UNITED STATES PATENT AND TRADEMARK OFFICE

APPLICATION NO.	FILING DATE	FIRST NAMED INVENTOR	ATTORNEY DOCKET NO.	CONFIRMATION NO.
10/620,940	07/11/2003	Ronald Ray Catt		8881

Office Action Summary

DETAILED ACTION

FIG. 1

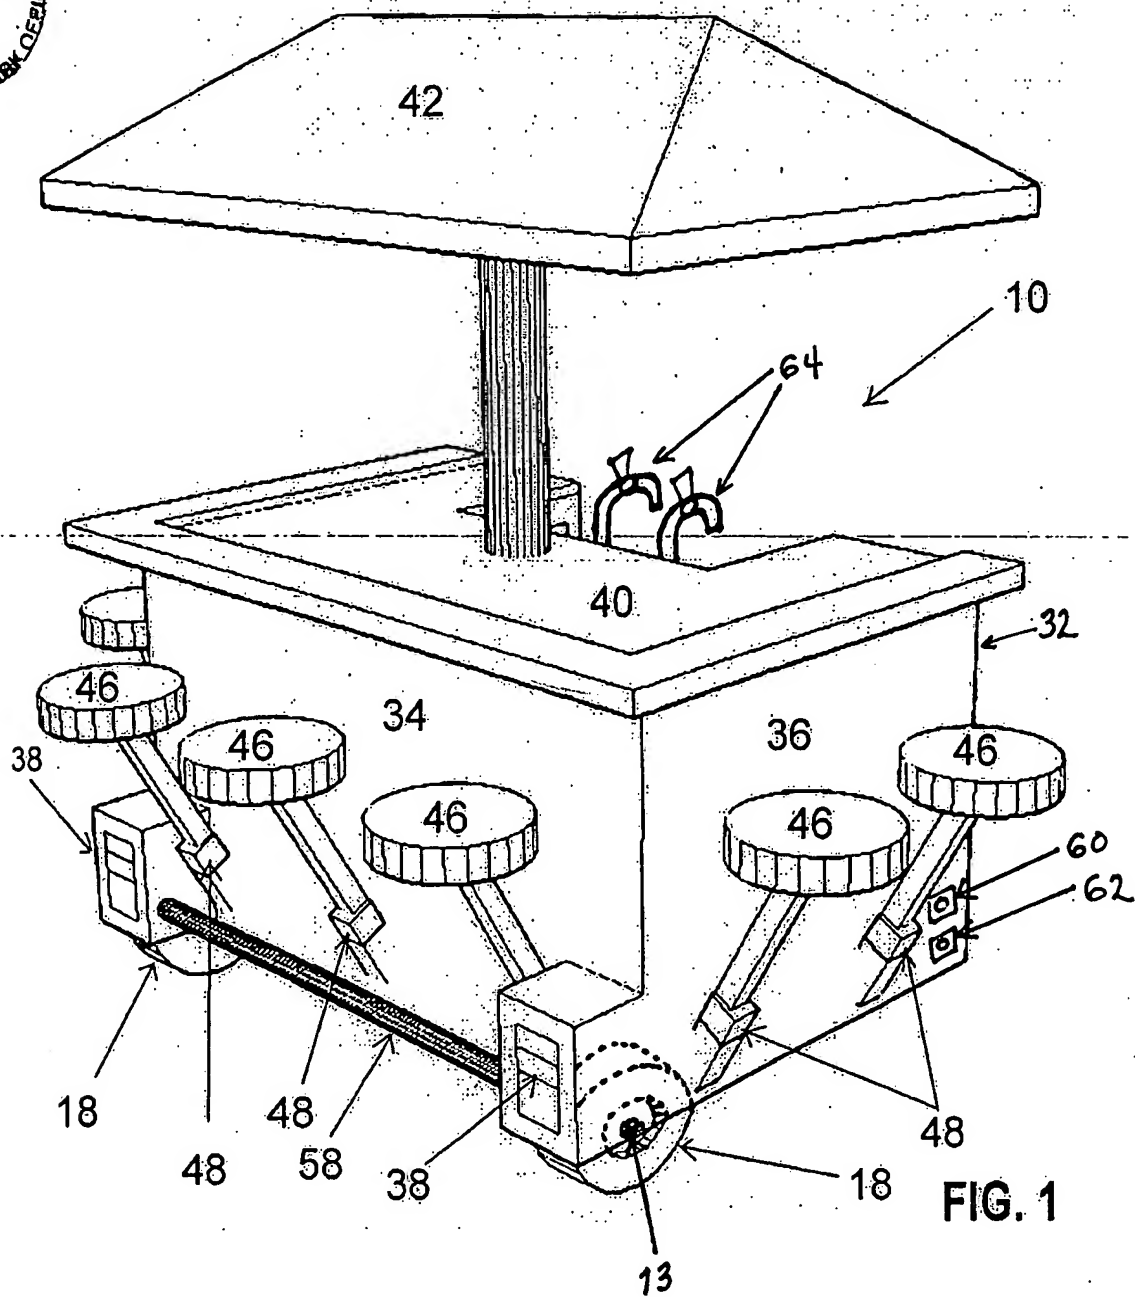
Figure 1, filed 7/21/2005 is approved.

approved
8/2/05
